Grimes City Council Agenda

Grimes City Council Meeting July 13, 2021 **In Person/Zoom at Grimes Community Center, 410 SE Main Street**

5. 1831 SE Princeton Drive – Paramount Kitchen and Bath Site Plan
6. Grimes Public Library Site Plan
7. Heritage Town Center Phase 2 Site Plan
8. Mega Storage Site Plan

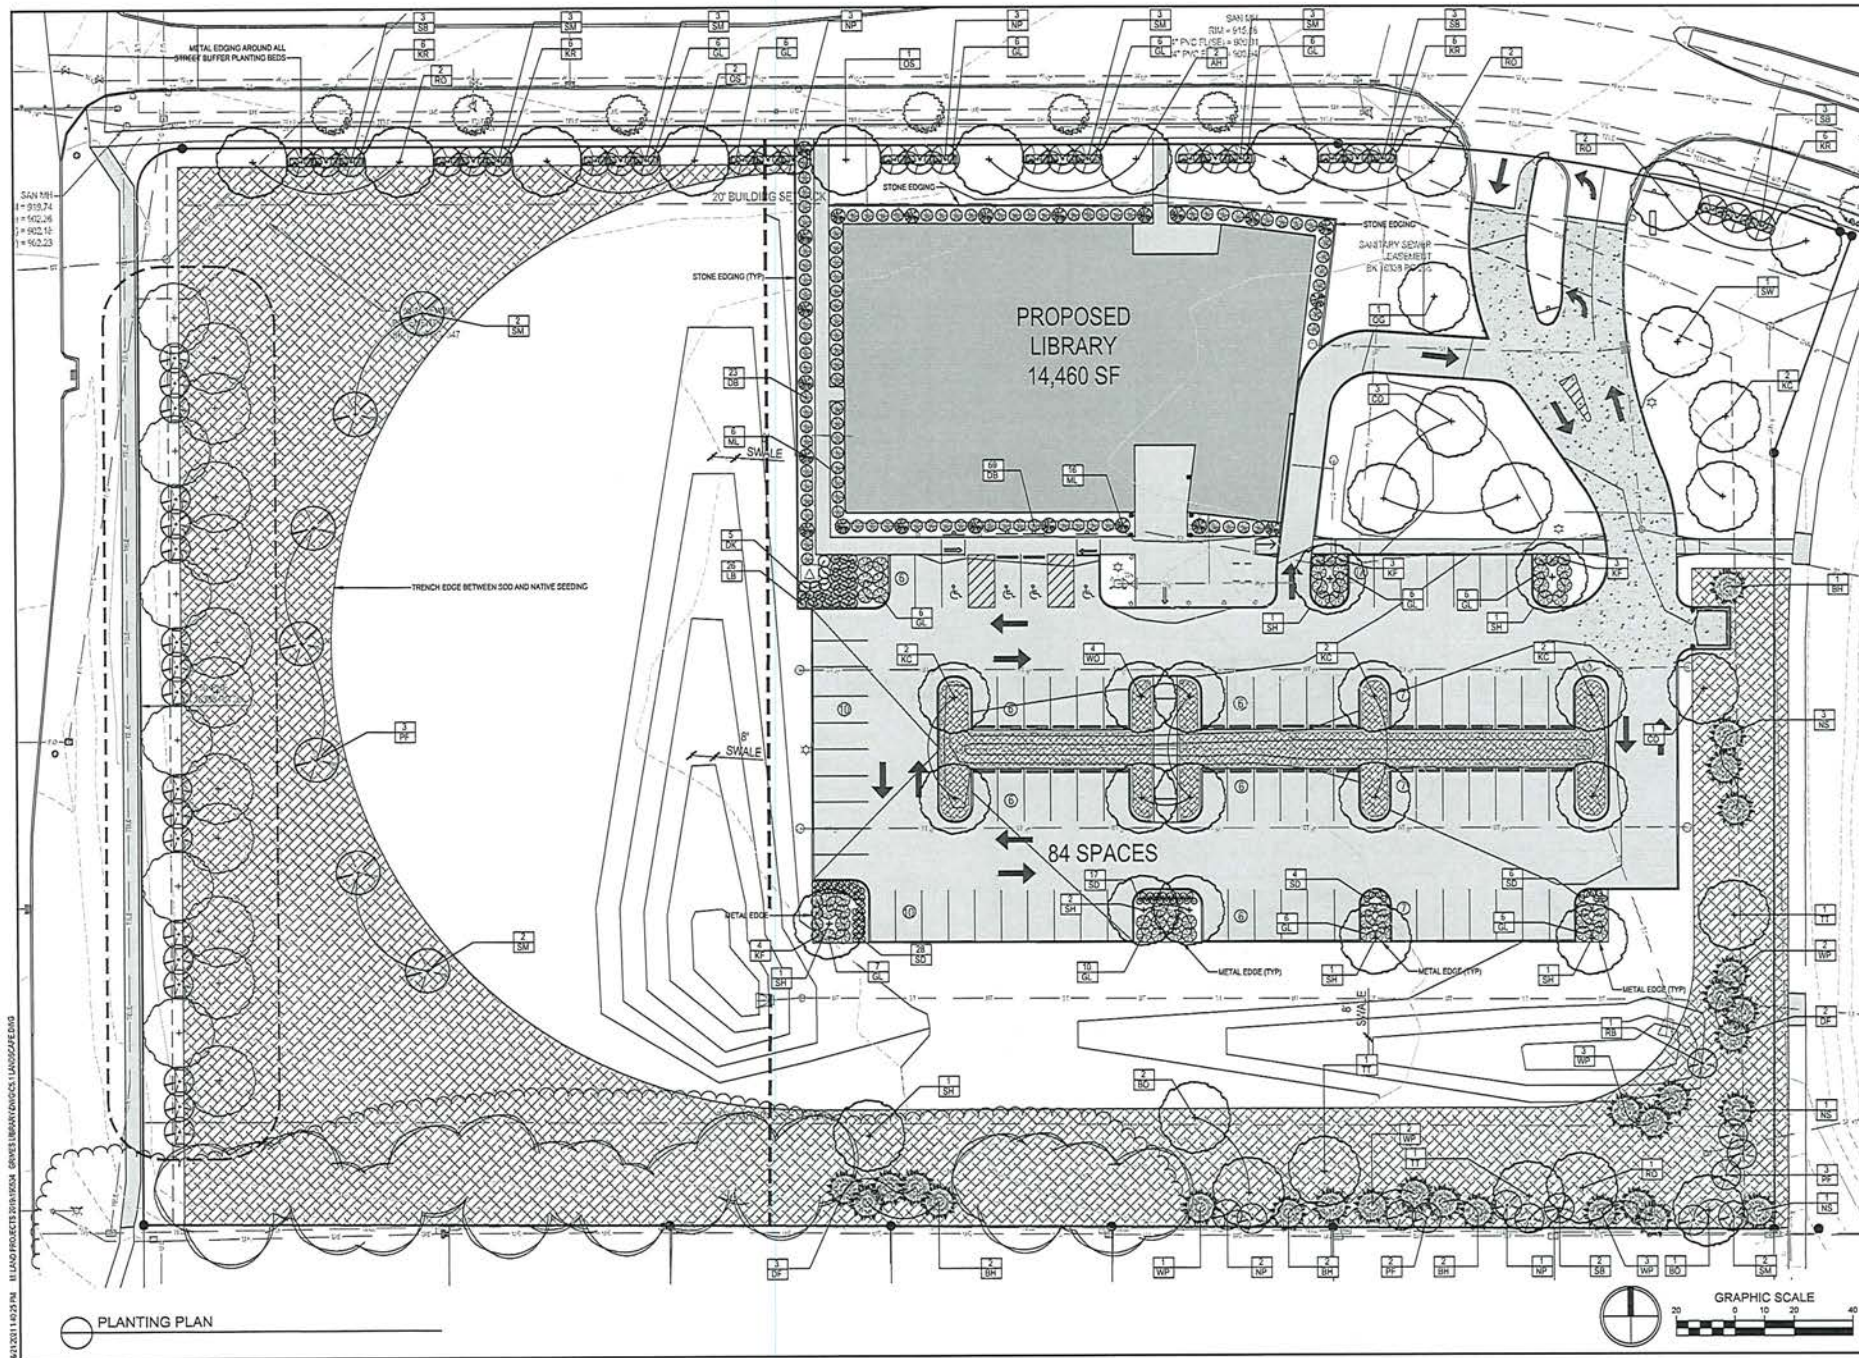
5. C3.1: The city would like the wheel stops in front of the rain garden removed, and instead use curb with curb openings.
6. C3.1 and C6.1: Provide rain garden details.
7. C5.1: Remove seed from the rain garden area and use river rock.
8. C4.1: Label critical crossings. Not all critical crossings were labeled.
9. C4.1 Some of the utilities are covered by hatches.
